**ADDENDUM  
NO. 3**

**October 11, 2024**

**Whiteland High School Ph 2: Café Kitchen Band Choir Auditorium**  
**300 E. Main Street**  
**Whiteland, IN 46184**

2 AUDITORIUM POWER SEQUENCING SYSTEM DIAGRAM N.T.S.

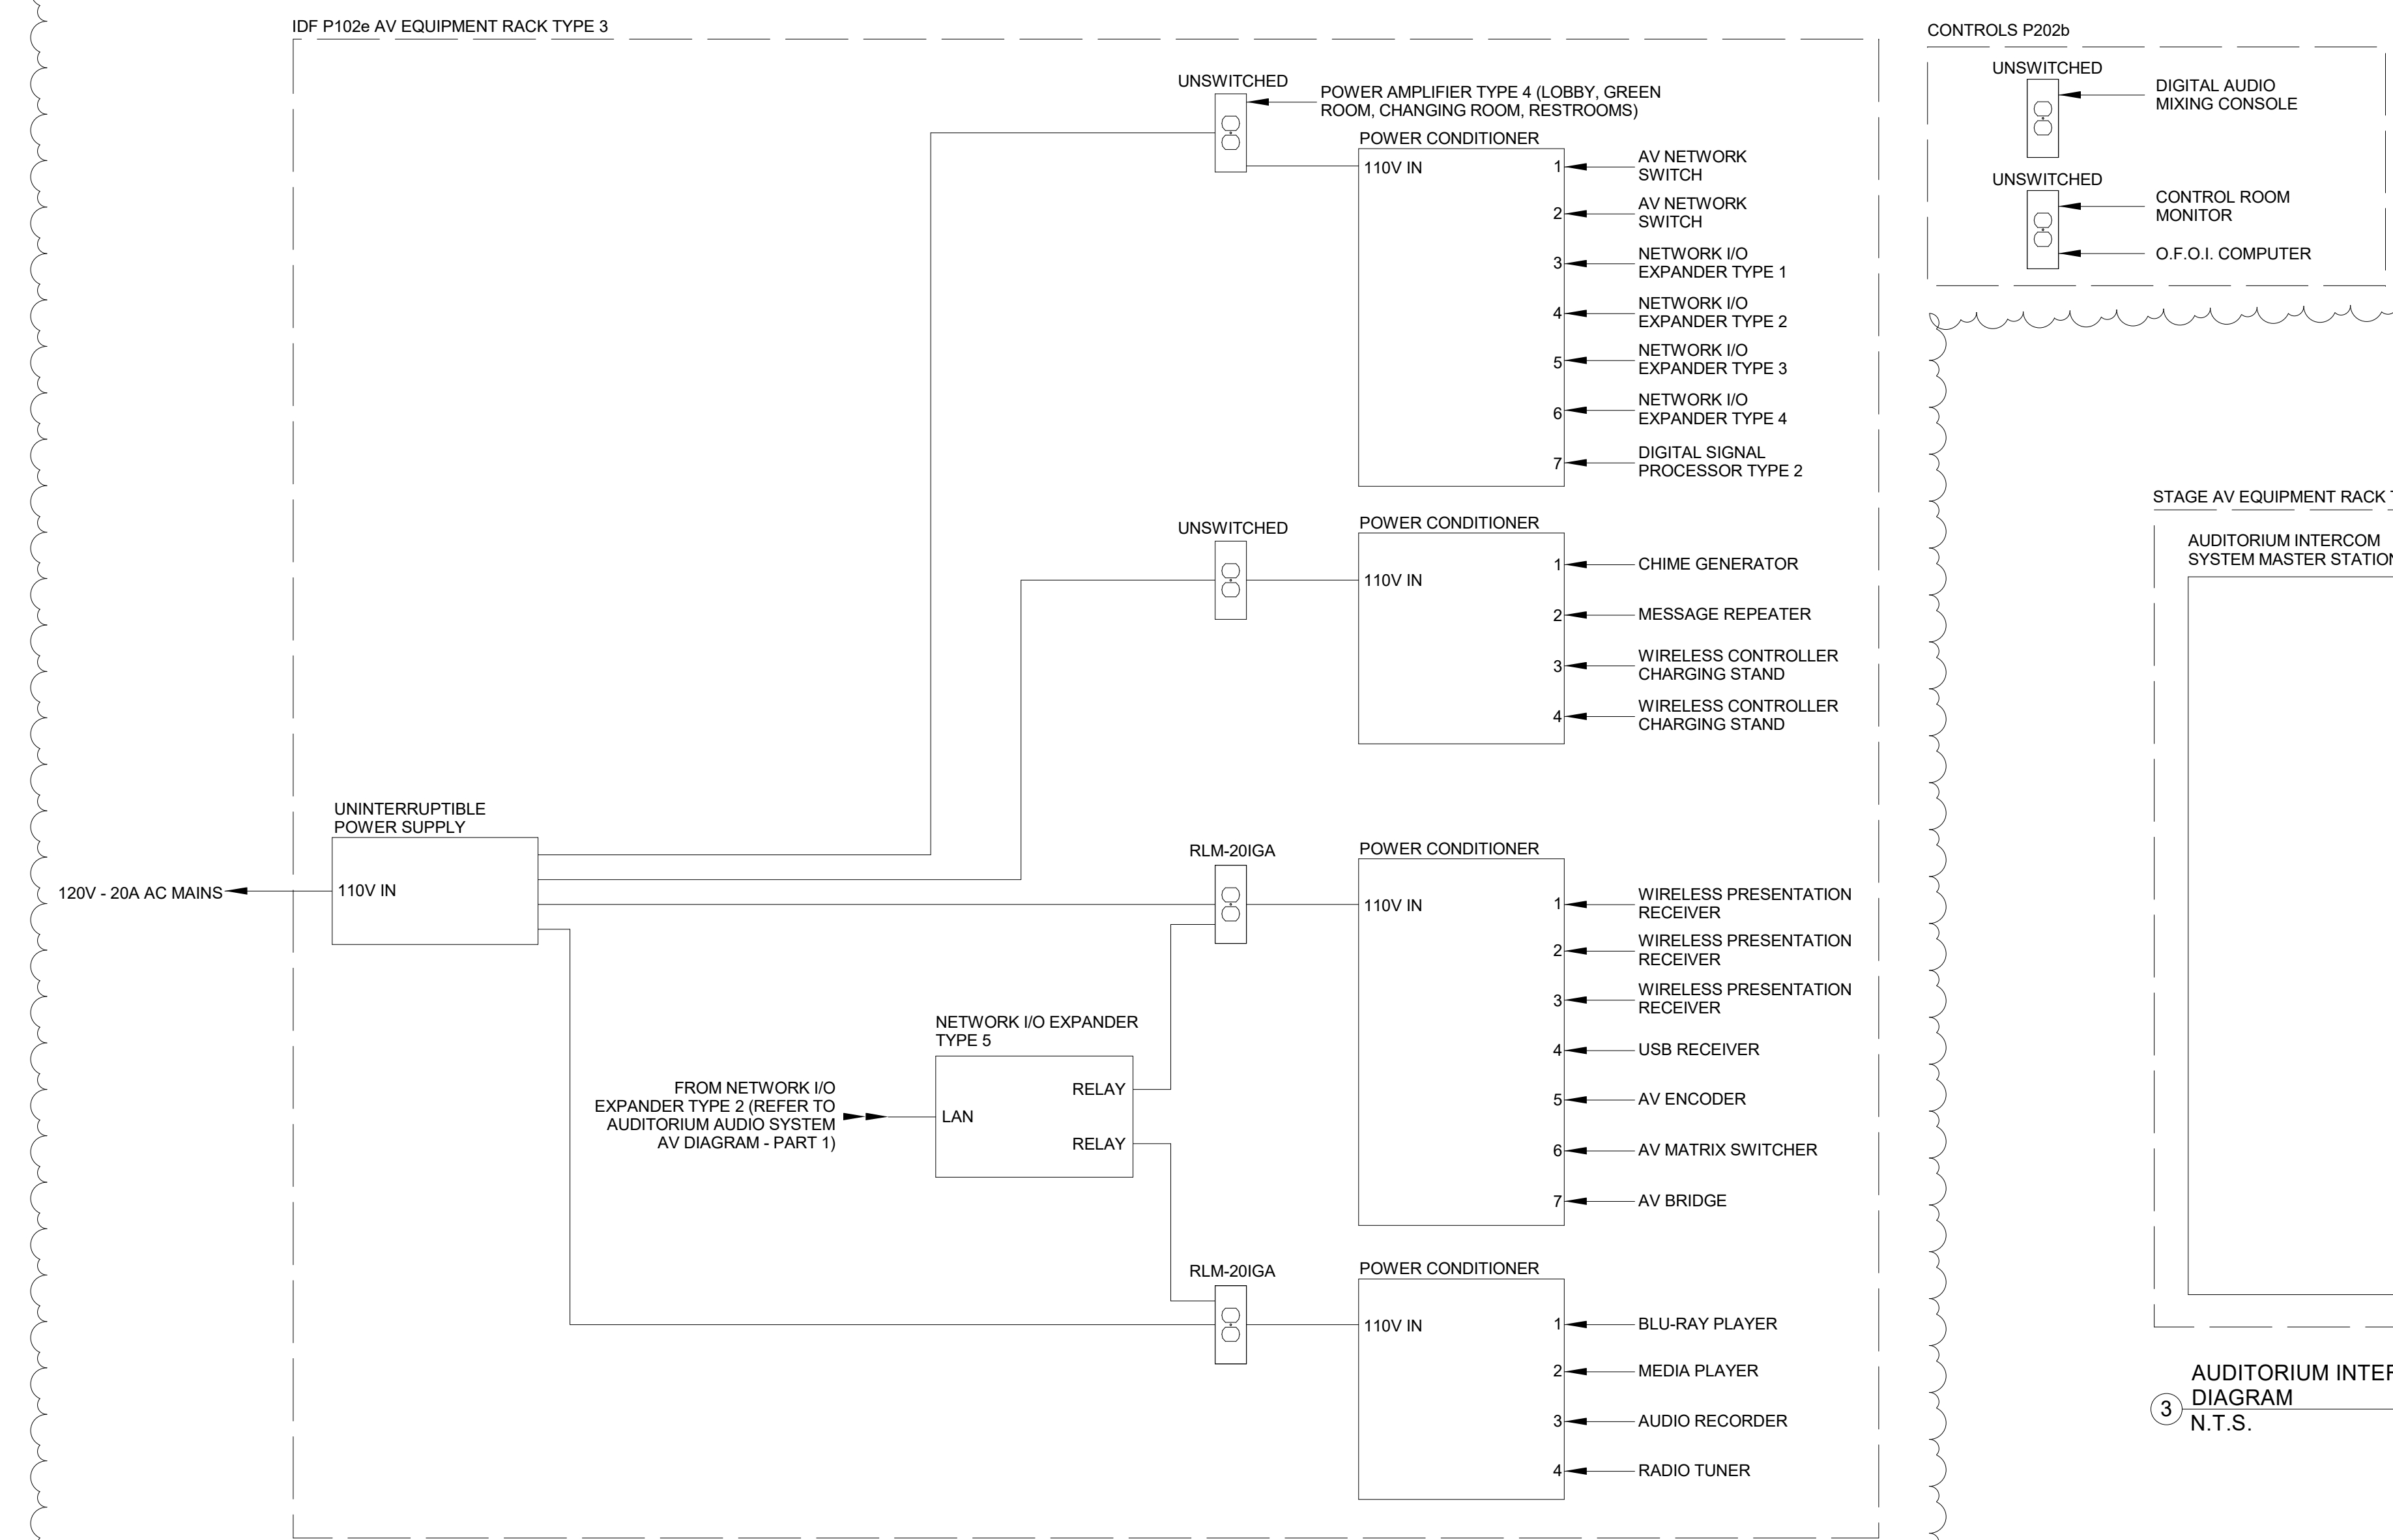
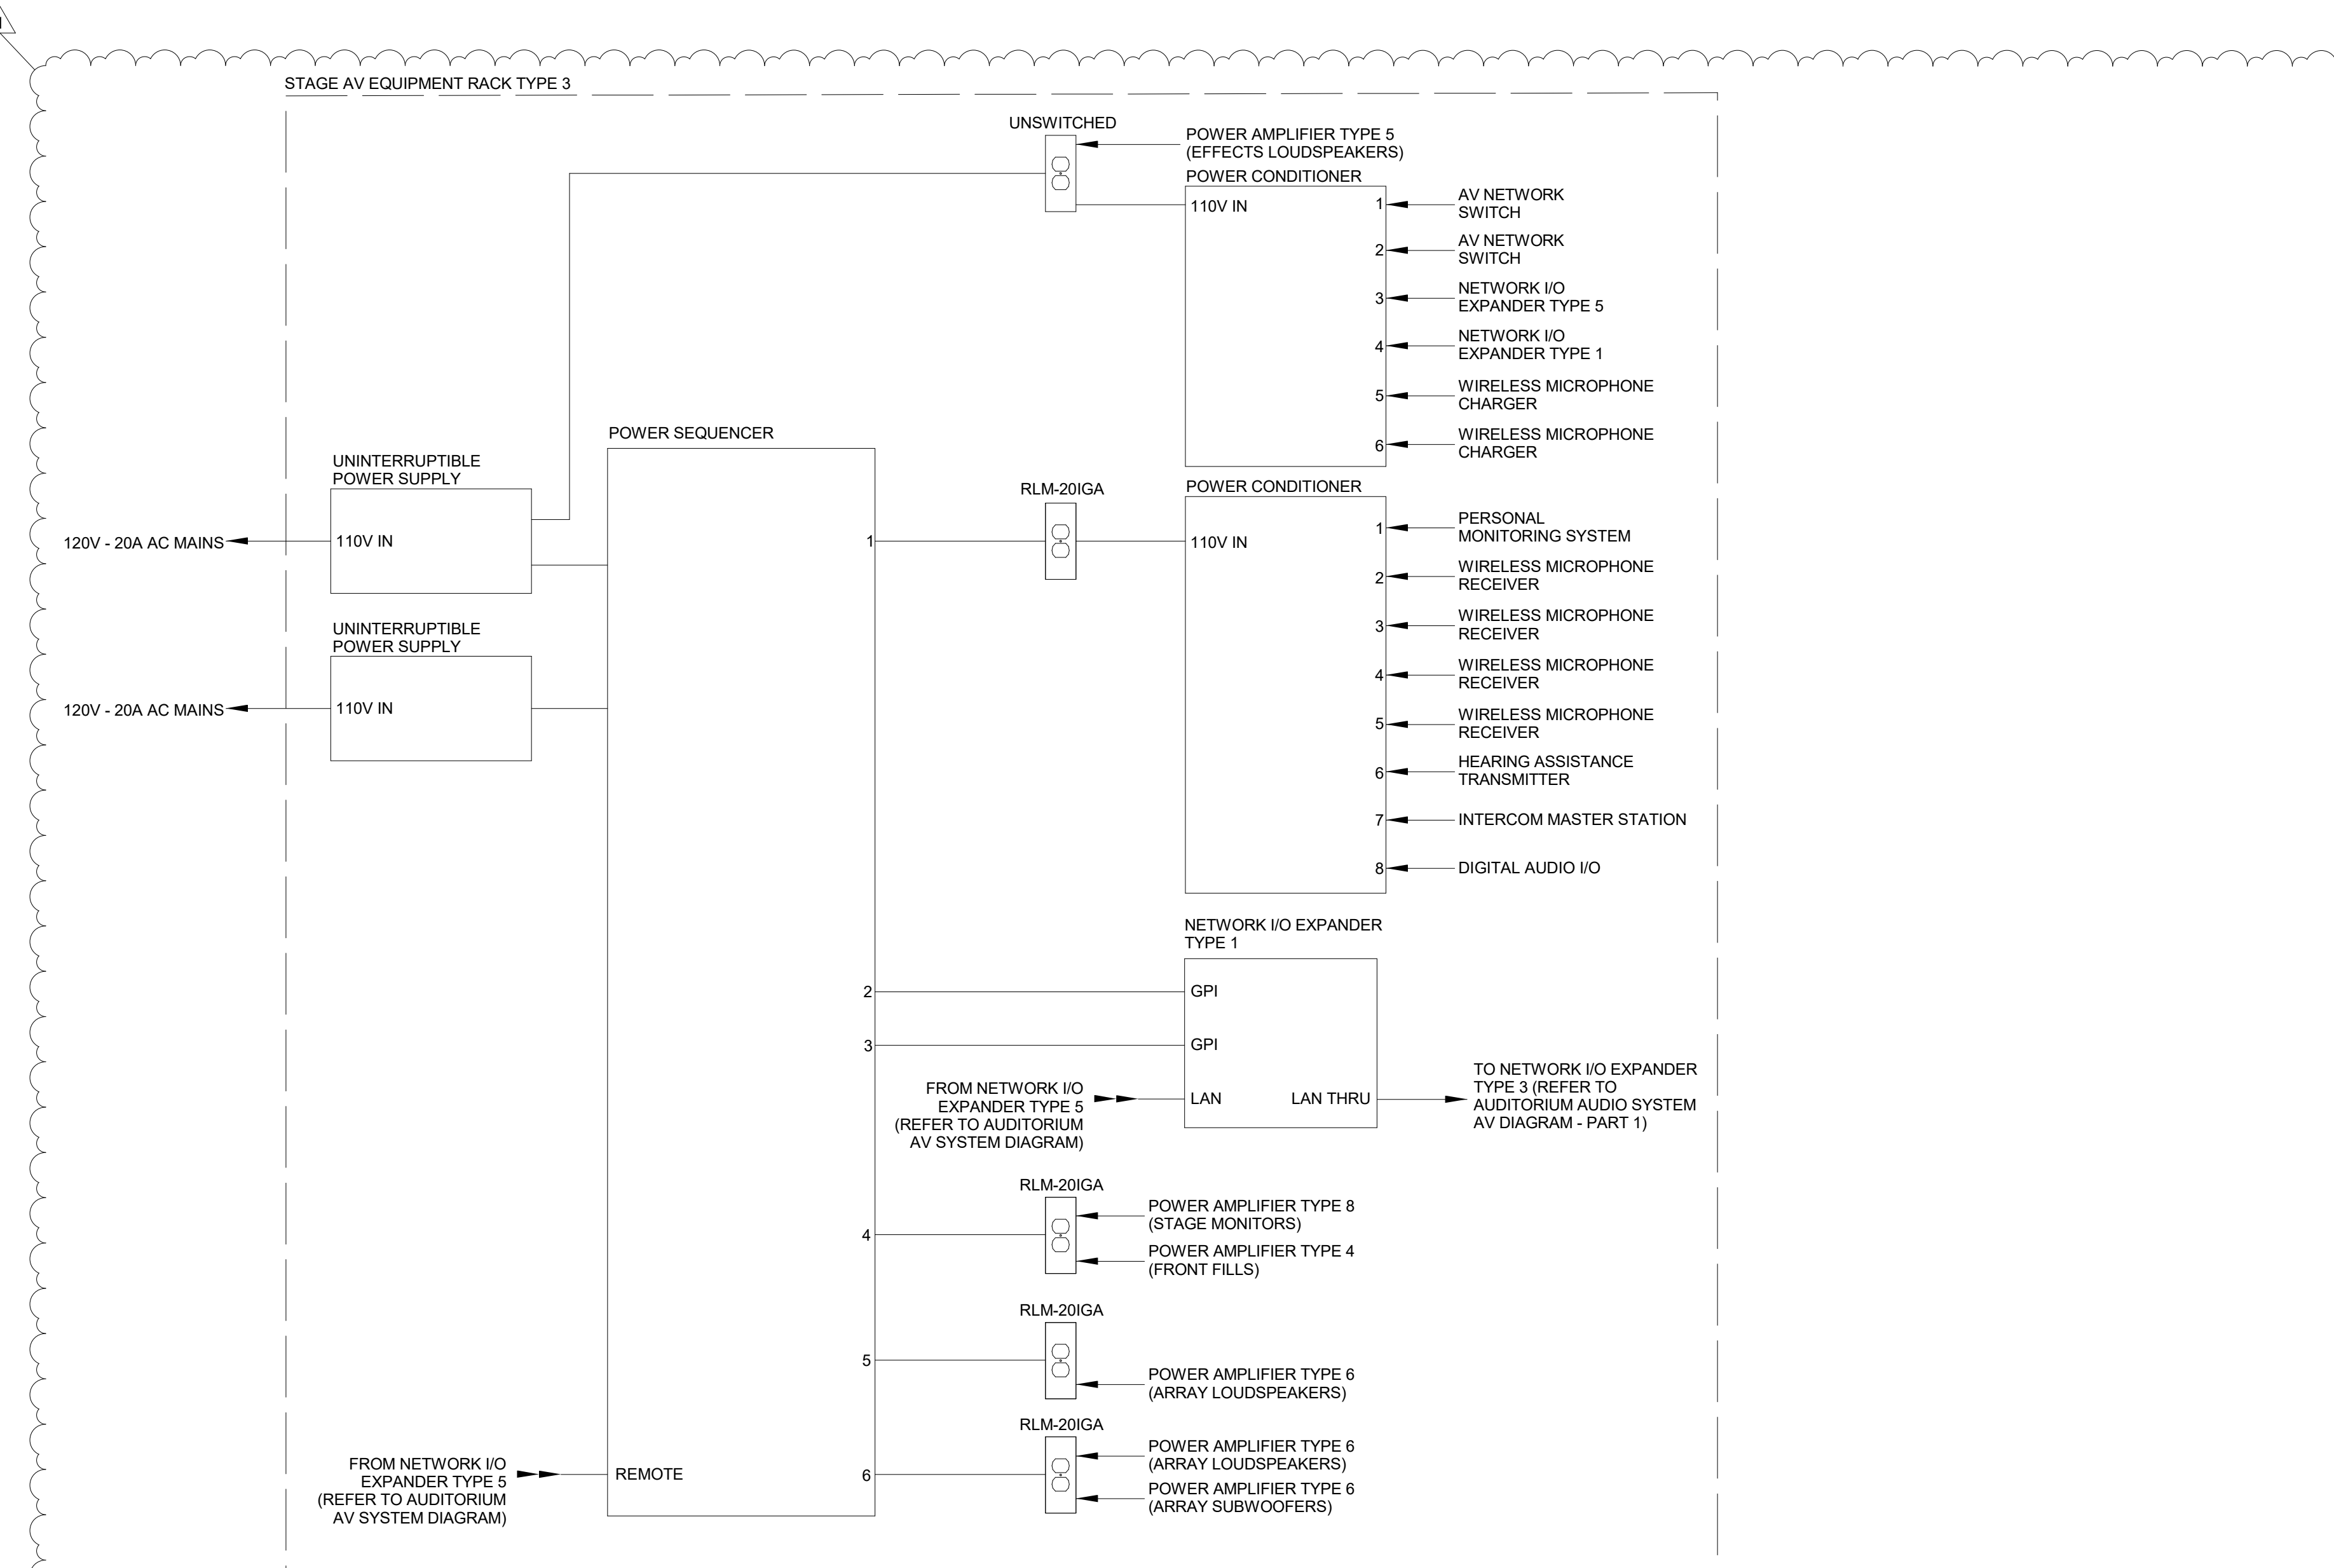
- a. Updated the Auditorium Power Sequencing AV Diagram. Added clearer connectivity from the power sequencer and UPSs in each AV equipment rack. Added clearer instructions on where to plug in each piece of equipment.
- b. Removed LAN connections from all wireless microphone receiver type 2 in the Auditorium Audio System AV Diagram – Part 2
- c. Added two wireless microphone chargers to the Auditorium Audio System AV Diagram – Part 2
- d. Added two additional intercom stations located on the stage right and stage left side of Stage P103. Put all intercom stations on dedicated set of A and B channel outputs.
